APPENDIX D

Offsite Dose Calculation Manual (ODCM),
Revision 6 and 7

OFFSITE DOSE CALCULATION MANUAL
PALO VERDE NUCLEAR GENERATING STATION
UNITS 1, 2 AND 3

REVISION 6

Page 80, Figure 6-5

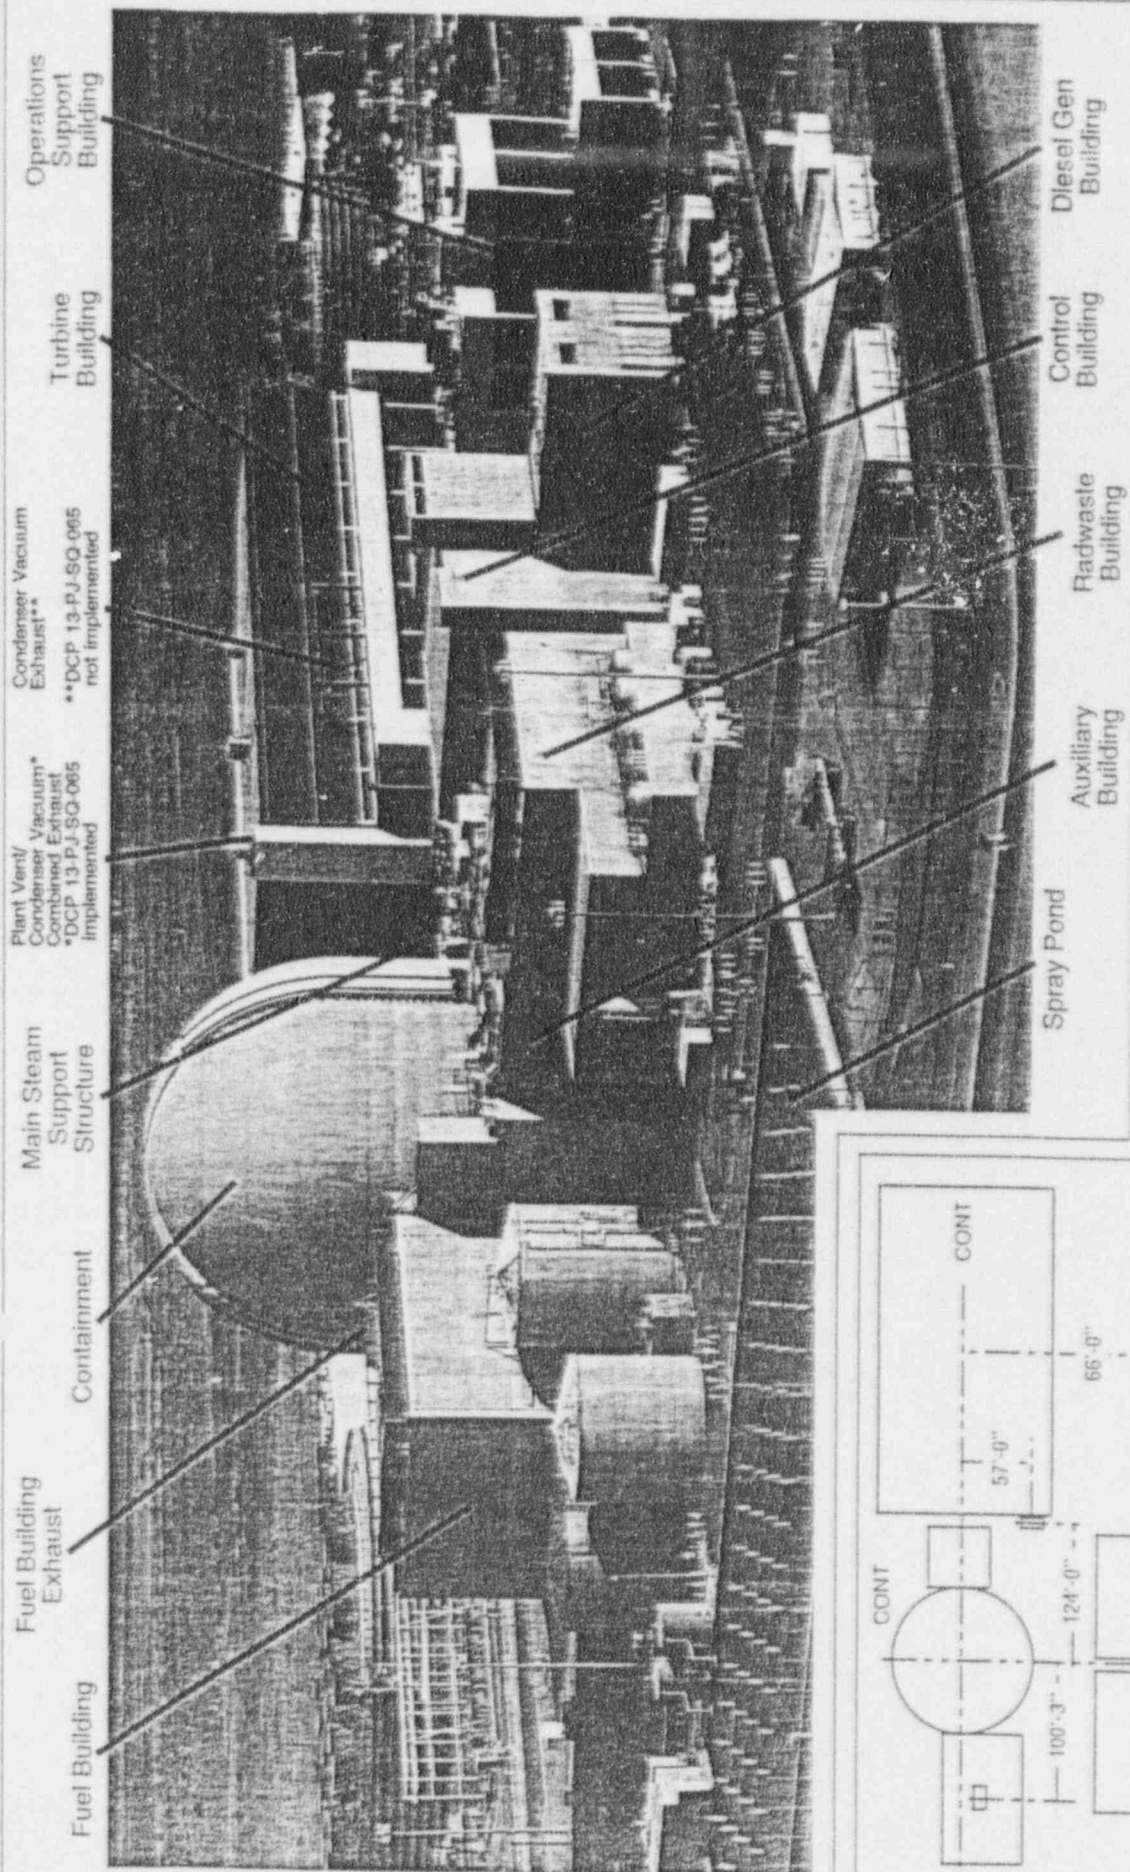
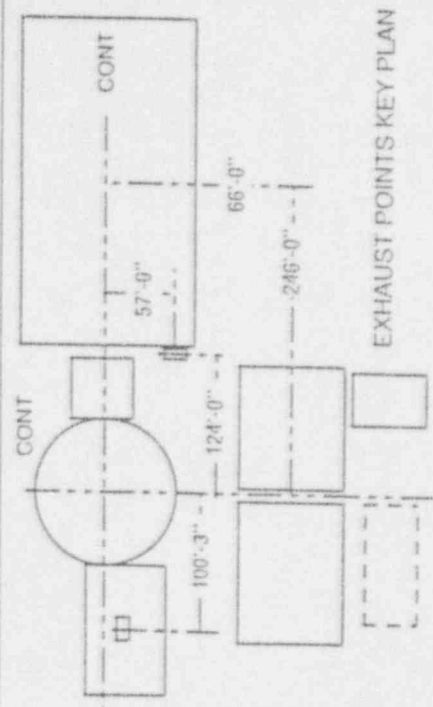
Indicates that the Condenser Exhaust (RU-141) discharge point is combined with the Plant Vent if DCP-13-PJ-SQ-065 has been implemented.

DCP 13-PJ-SQ-065, in part, reroutes the Condenser Vacuum Exhaust from a separate release point, to a combined release point with the Plant Vent. The ODCM needs to be revised to reflect this change. The actual release will now be monitored by the Plant Vent effluent monitors, RU-143 and/or RU-144. RU-141 and RU-142 are no longer effluent monitors. RU-141 will become an in-duct monitor and RU-142 will be removed. This ODCM revision removes RU-141 and RU-142 as effluent monitors following the implementation of DCP 13-PJ-SQ-065.
